COMMUNITY DEVELOPMENT DEPARTMENT

HEARING DATE: 5/5/2022

SUBJECT: H-2022-0024
Timberline North (Timberline No. 2) PFP

I. PROJECT DESCRIPTION

B. Combined Preliminary/Final Plat (stamp date: January 12, 2022)

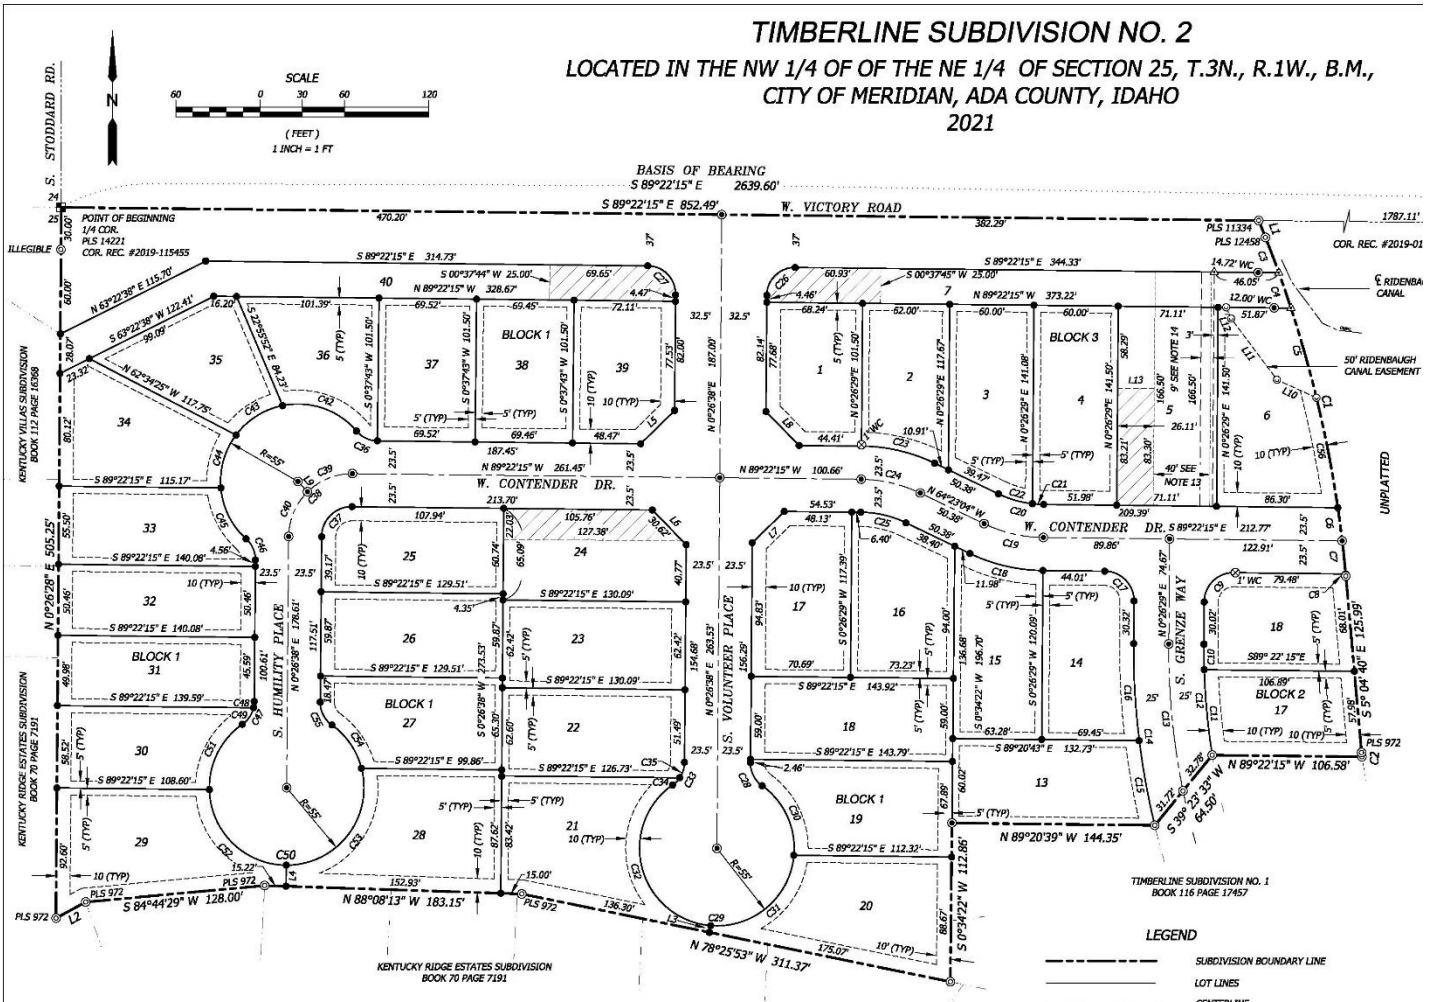
3. The final plat prepared by Sawtooth Land Surveying, LLC, with a stamped date of January 12, 2022, shall be revised as follows at the time of Final Plat Signature submittal:

- a. Note #5 shall be corrected to show read "...Title 11 of Meridian City Code..." instead of "Title II..."
 - b. Note #14 – add applicable instrument number.

- c. Add ACHD R/W Instrument number on final plat where ultimate right-of-way is shown.
4. The submitted landscape plan prepared by Stack Rock Group, dated 01/14/2020 shall be revised as follows at the time of Final Plat Signature submittal:

LANDSCAPE PLAN - AREA 2
 SHEET L1.03
 DATE: 03/15/2023

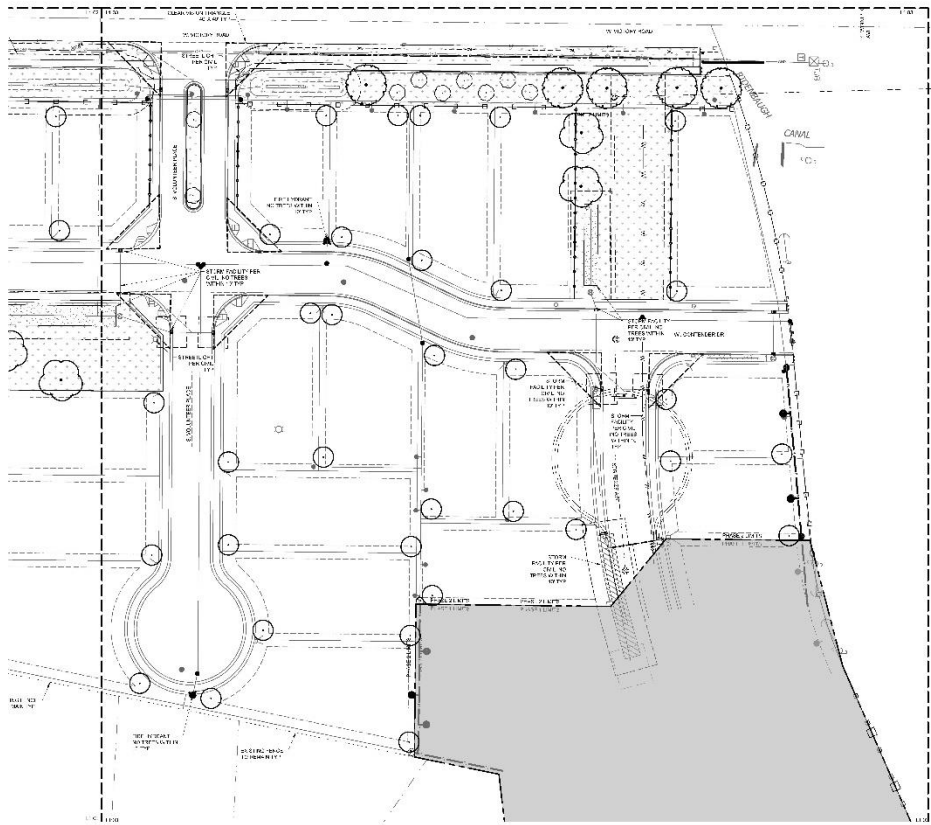
- a. With submittal of the final plat Mylar application, the applicant shall provide a revised landscape plan per UDC requirements and standards set forth in 11-3B-7C.5a: "If the unimproved street right of way is ten feet (10') or greater from the edge of pavement to edge of sidewalk or property line, the developer shall maintain a ten foot (10') compacted shoulder meeting the construction standards of the transportation authority and landscape the remainder with lawn or other vegetative ground cover. (Ord. 16-1672, 2-16-2016)." This condition shall be applied to the Northwest corner of the property abutting W. Victory Road.
